BP Cherry Point Refinery  
4519 Grandview Road  
Blaine, Washington 98230  
Telephone 360-371-1500

**Re: Response to Questions and Issues Related to Cherry Point BART Technical Analysis Report**

## Response to BP Cherry Point Refinery BART Analysis Questions

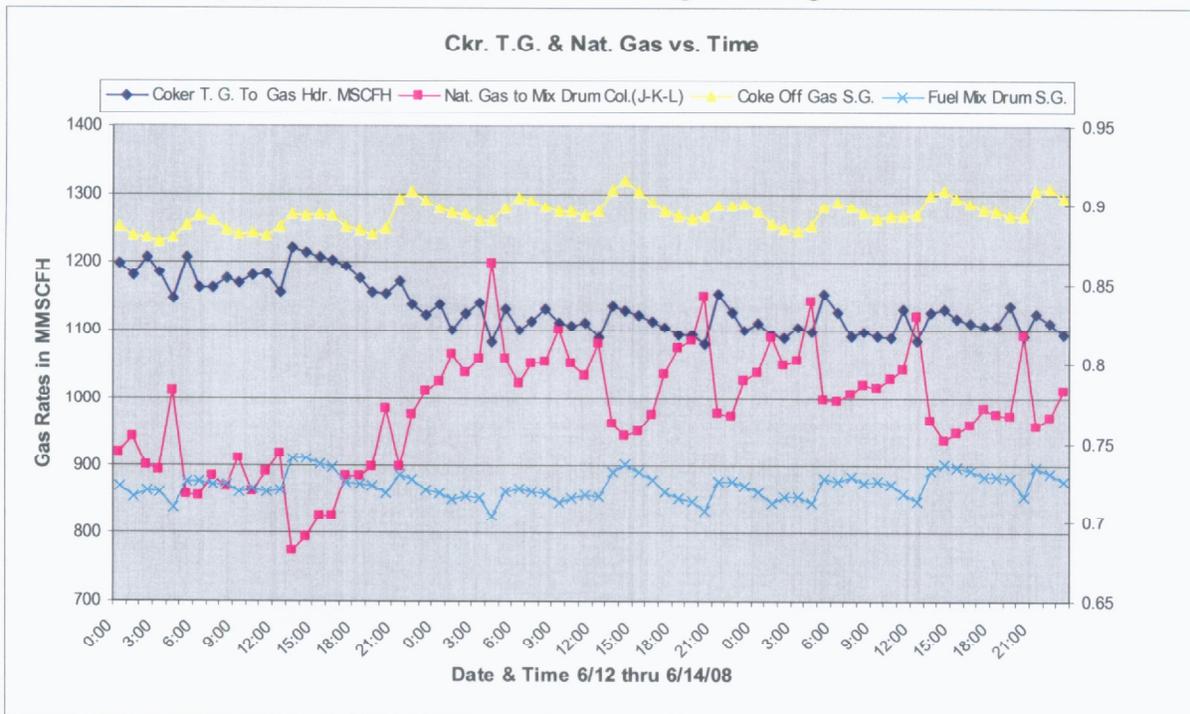
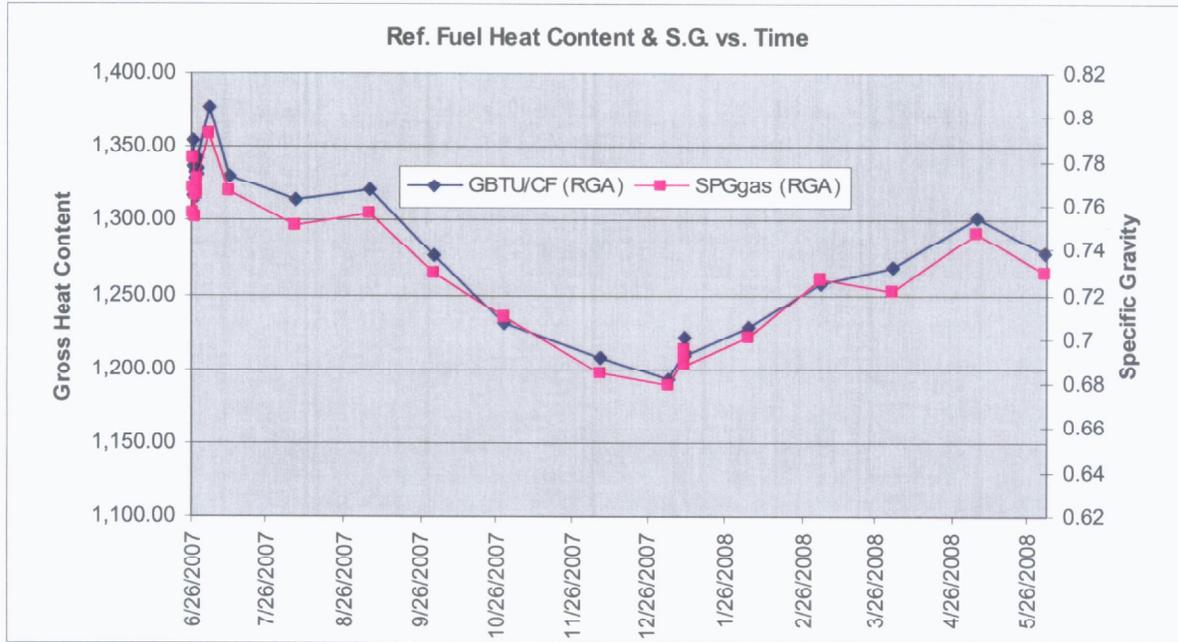
**Question 1:** BP has stated that the representative average /nominal heat content of the refinery gas used at the plant was 1,352 BTU/ft<sup>3</sup> (2003-2005 data), with an SO<sub>2</sub> emission factor of 0.0364 lb/MMBtu. Swings in refinery gas specific gravity (and heat content) are cited as affecting the viability of several BART options. We know that sulfur content can also vary. What is the range of refinery gas heat and sulfur contents, and how might the heat and sulfur content changes be described statistically over a day, week or year? What operations and refinery gas component variables drive these changes?

As shown in the graph below, the largest routine impact on heat content is the cyclic nature of the coker operation. Coker gas fluctuates cyclically with drum swings. Specific gravity (s.g.) of the fuel gas and coker gas is measured continuously and provides a correlation to the heat value of the gas. The impact of coker gas on imported natural gas is illustrated below along with the change in mix drum specific gravity (s.g.) with coker s.g.

The second graph shows that heat content and s.g. track together.
